ORIGINATION FORM

Proposed Revisions to a Standard Plans Index

Index Number: 102-200

Index Title: TEMPORARY ACROW 300 SERIES DETOUR
BRIDGE GENERAL NOTES AND DETAILS

DETAILS FOR FDOT SUPPLIED FIXED BEARINGS

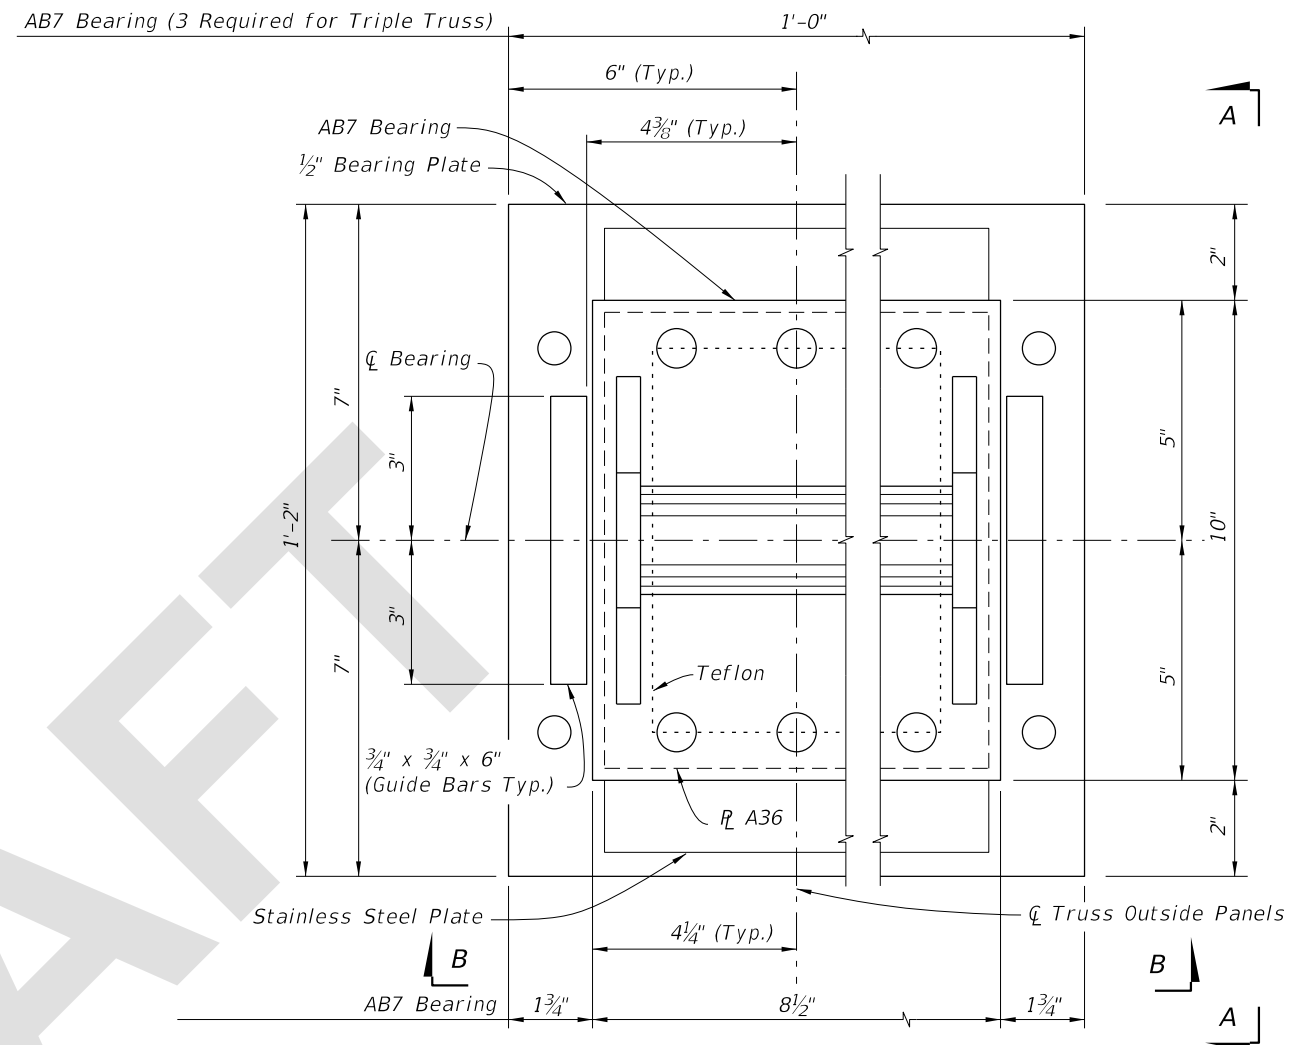
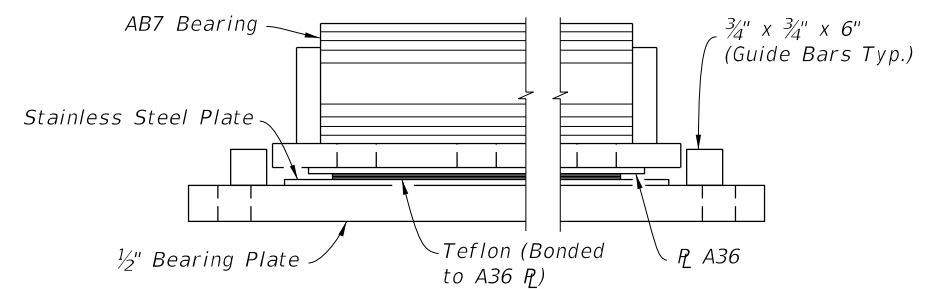
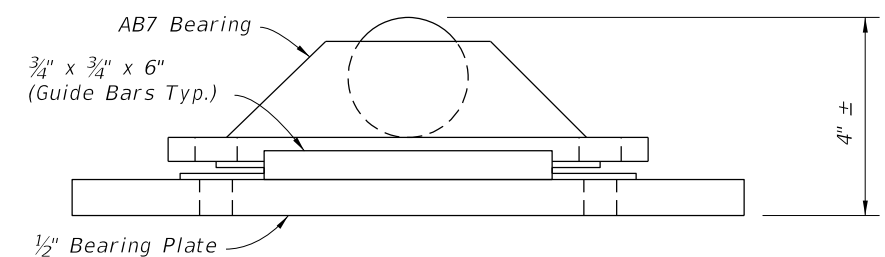
Sheet 4: Removed double bearing notes and details.

Sheet 5: Removed double bearing notes and details.

Sheet2-6: Currently FDOT only has single bearings in inventory.

LAST REVISION 11/01/20	DESCRIPTION: 11/01/22	 FY 2022-23 STANDARD PLANS	TEMPORARY ACROW 300 SERIES DETOUR BRIDGE GENERAL NOTES AND DETAILS	INDEX 102-200	SHEET 6 of 7
--------------------------------------	--------------------------	--	---	------------------	-----------------

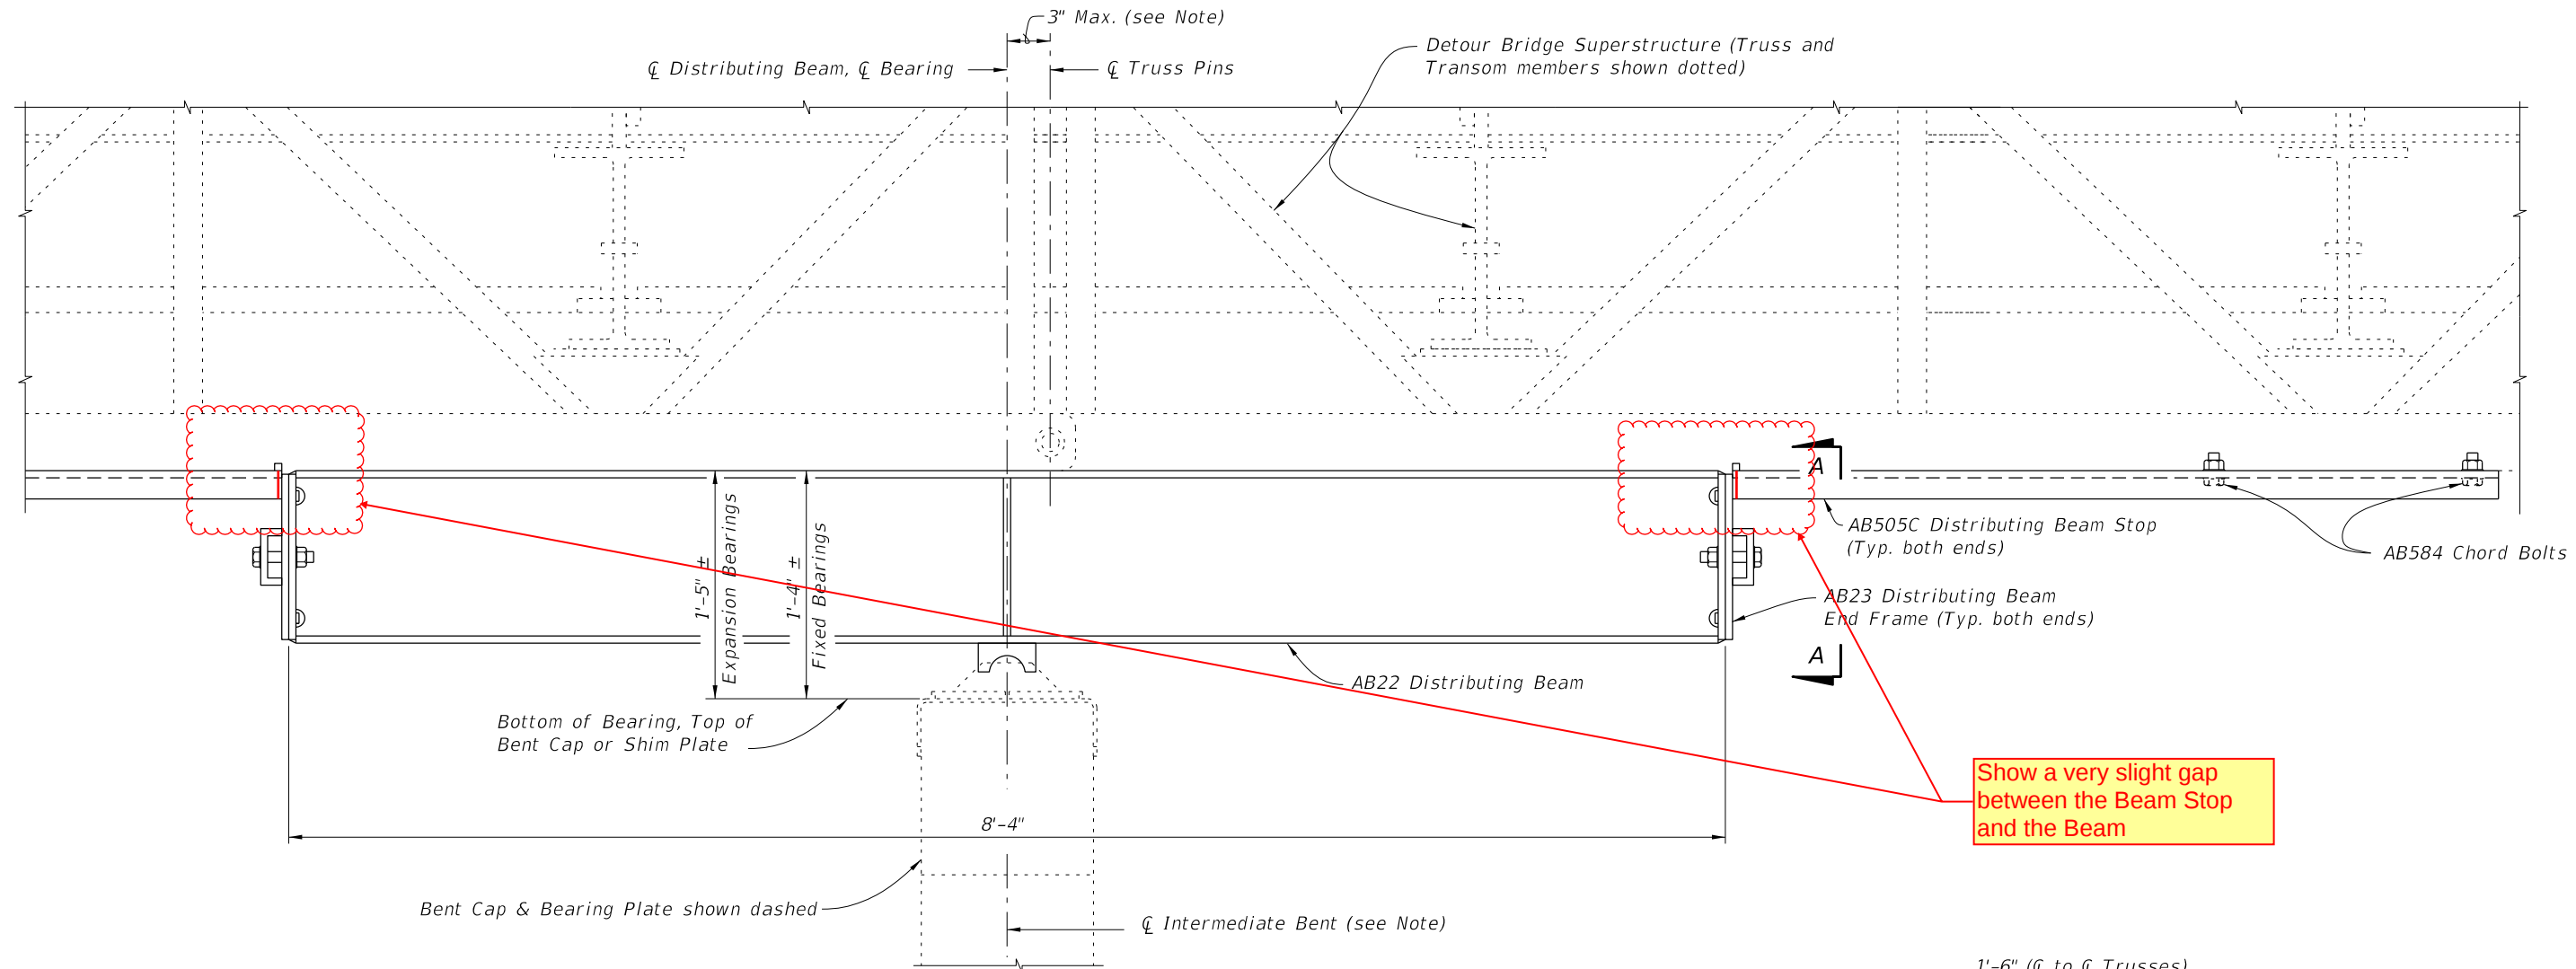
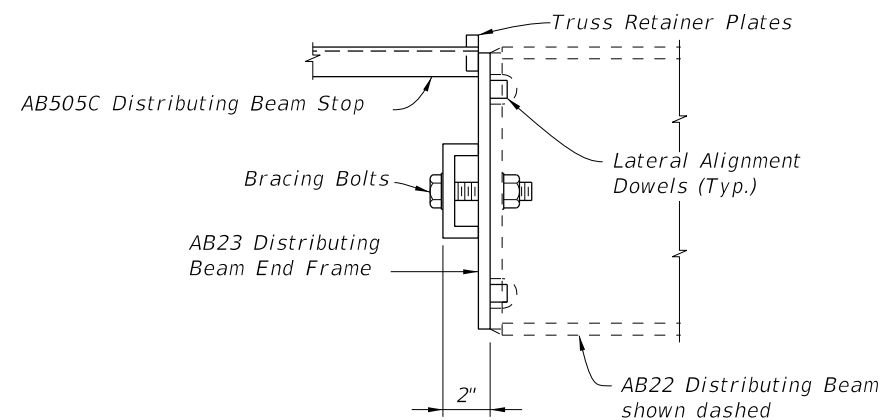
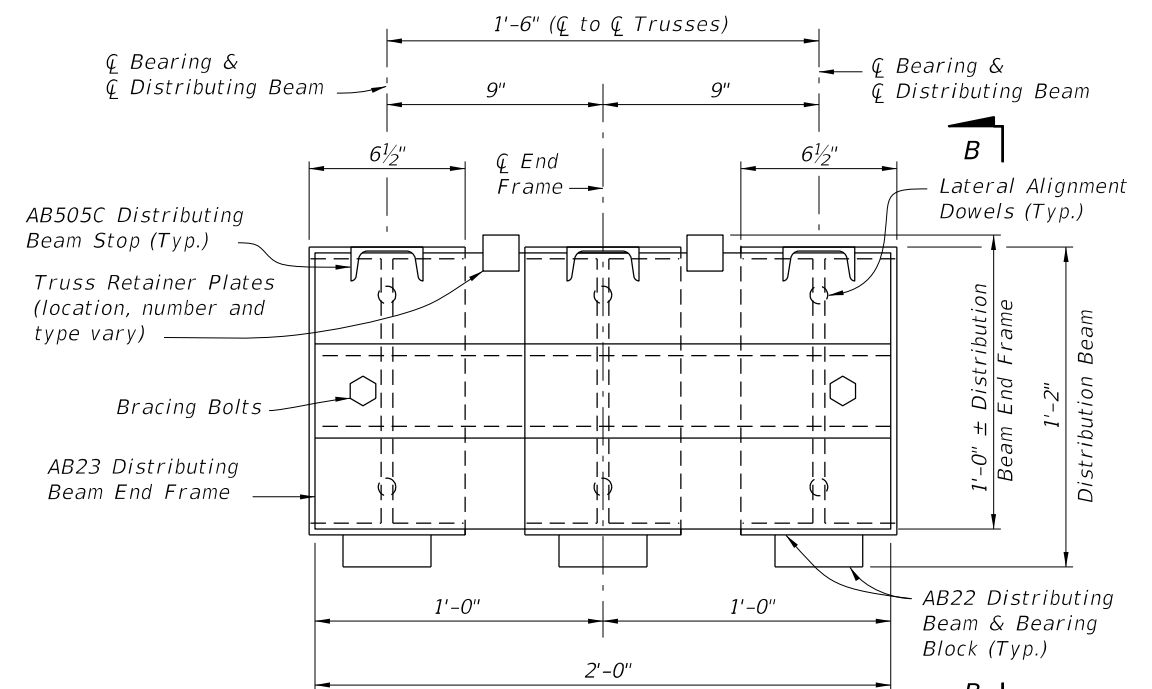
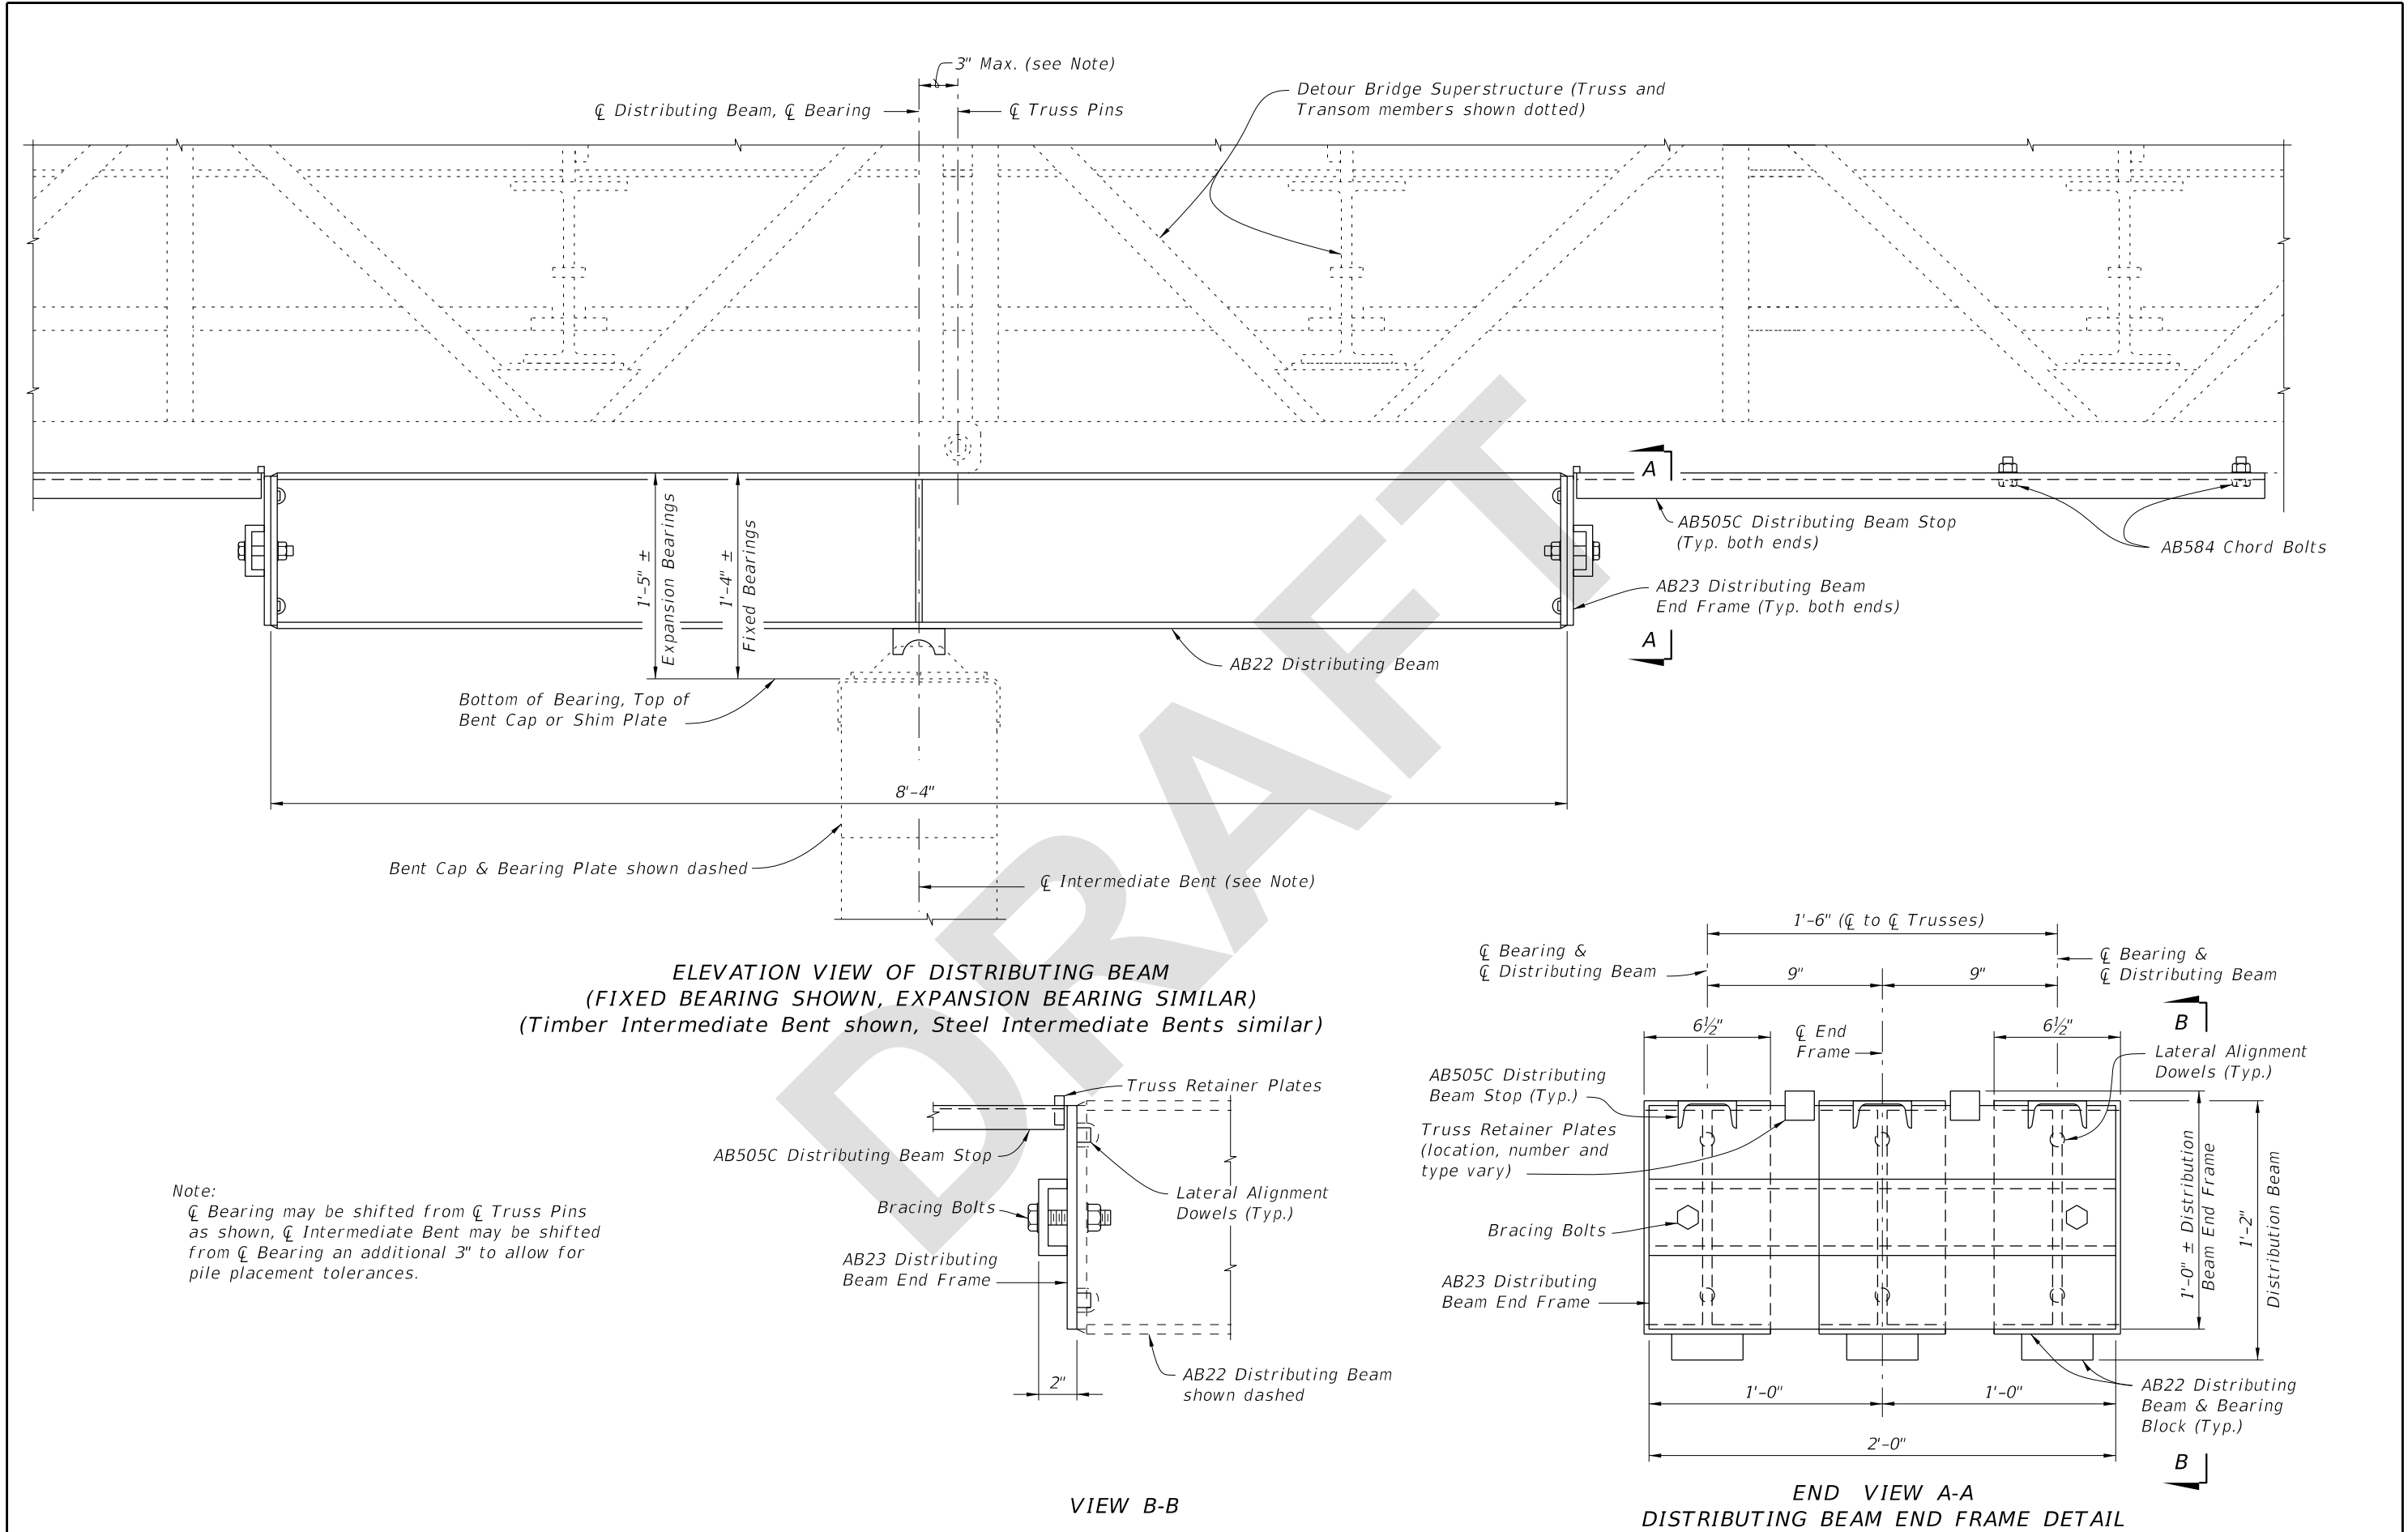
Sheet 6: Added slight gap between beam stops and beam.

Sheet 6: Beam stops do not have to be exactly flush.
